INFORMATION BULLETIN

Roadie Software Upgrade 1.9E

Applies to the Following Products	Prepared For
<ul style="list-style-type: none"> Roadie 25K Roadie 25K LE Roadie HD+30K Roadie HD+35K 	All Internal and External Customers

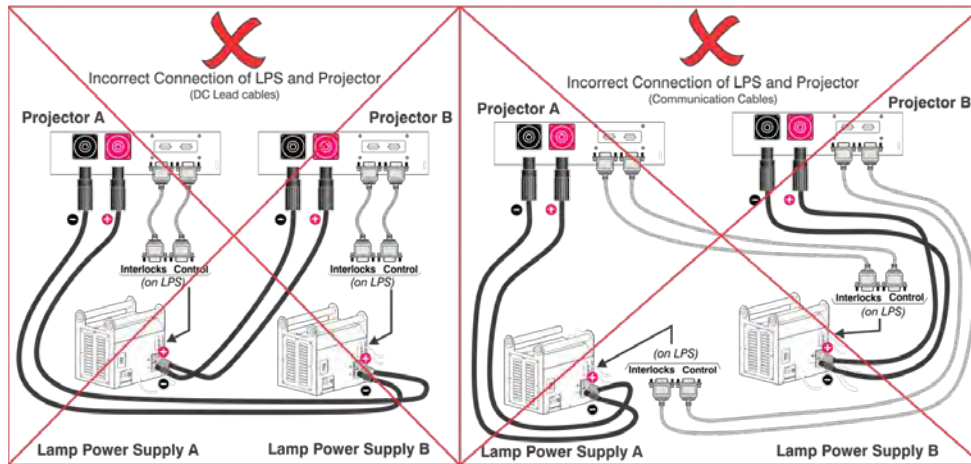
Christie was recently made aware of a situation in which a multi-projector installation was wired incorrectly. The DC leads of one lamp power supply were cross-connected to a second projector head but the interlock and control cables were not, causing a fire to ignite within the projector head.

Christie recommends that the units currently installed **MUST NOT** be operated until the installation has been verified as correctly connected. Use this diagram to determine if the connections between the projector head and LPS are correct:

To confirm that the cross-connection has not occurred, power only one LPS and projector pair at a time. DO NOT power multiple LPS and projector heads simultaneously. Before you turn on multiple projectors, you must confirm each projector head and lamp power supply are connected and operating correctly.

In addition to the **primary resolution**, Christie has developed software version 1.9E to further minimize the risk of the cross-connection hazard. The new version of software reads the light sensor output on the Roadie projector when the lamp is lit, and provides feedback to the projector electronics that indicates if the lamp is on or off. This feedback loop helps to minimize the chance of a projector operating with a cross-connected ballast in a multiple projector application.
